## **Public Comments of the American Gas Association**

### **U. S. Environmental Protection Agency (EPA): “ENERGY STAR Program Requirements, Product Specification for Furnaces, Eligibility Criteria, Version 3.0: Draft 2”**

**December 29, 2010**

Exhibit 2.

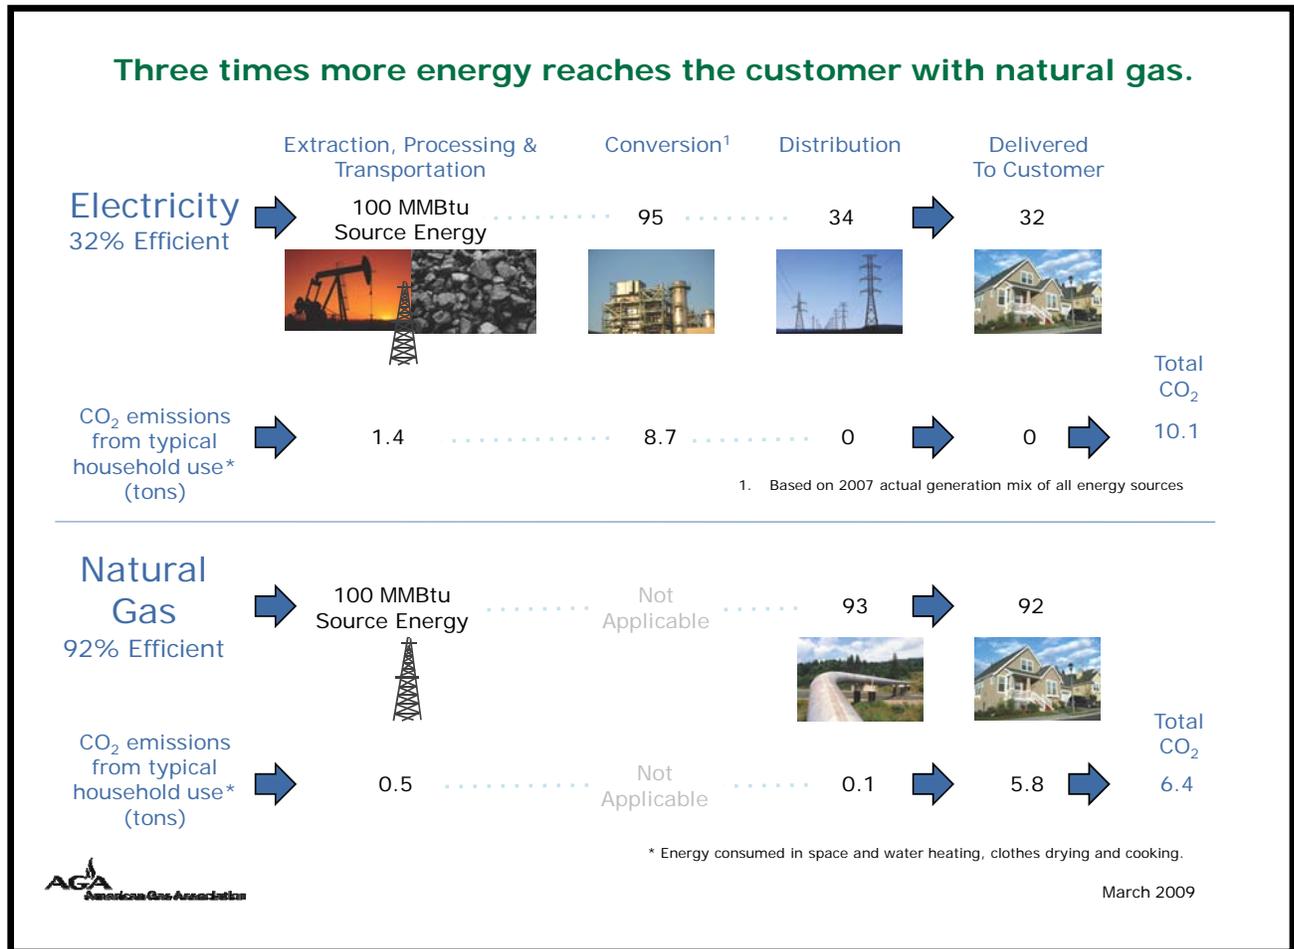
As Exhibit 2 shows, source energy inefficiencies associated with both natural gas and electricity usage must be accounted for if relative efficiencies of competing systems (gas central furnaces and electric heat pumps and resistance heating) are to be compared. Using data from the U. S. Energy Information Administration (EIA) Annual Energy Outlook and related EIA sources, efficiency losses upstream of direct gas consumption account for approximately 8% of energy produced, while for electricity efficiency losses account for 68% of energy produced, based on national average data. Use of source energy as the basis for energy efficiency comparisons is consistent with the recommendations of the National Research Council's Committee on Point-of-Use and Full-Fuel Cycle Measurement Approaches to Energy Efficiency Standards for use in appliance efficiency minimum efficiency rulemakings.<sup>1</sup>

In making the comparisons of ENERGY STAR requirements, stated above, AGA used the proposed minimum efficiency requirements for gas furnaces (92% and 95% AFUE) for comparison with the current minimum Heating Seasonal Performance Factor (HSPF) efficiency requirements for air-source heat pumps in the ENERGY STAR program (8.2 HSPF). Equivalent heating performance was calculated using the conversion methods documented from the ENERGY STAR website. These conversions allow calculating equivalent AFUE factors for HSPF-rated heat pumps. Both gas furnace AFUEs and equivalent AFUEs for heat pumps were converted to source-adjusted efficiencies using the 8% national average loss factor for gas and 68% national average loss factor for electricity.

In view of these issues, AGA believes that EPA should maintain the current ENERGY STAR minimum efficiency for gas furnaces at 90% AFUE, at least until heat pump efficiency requirements can be increased to comparable minimum efficiencies (e.g., 9.1 HSPF for the competing minimum AFUE requirement of 92% for gas furnaces, based on AGA calculations).
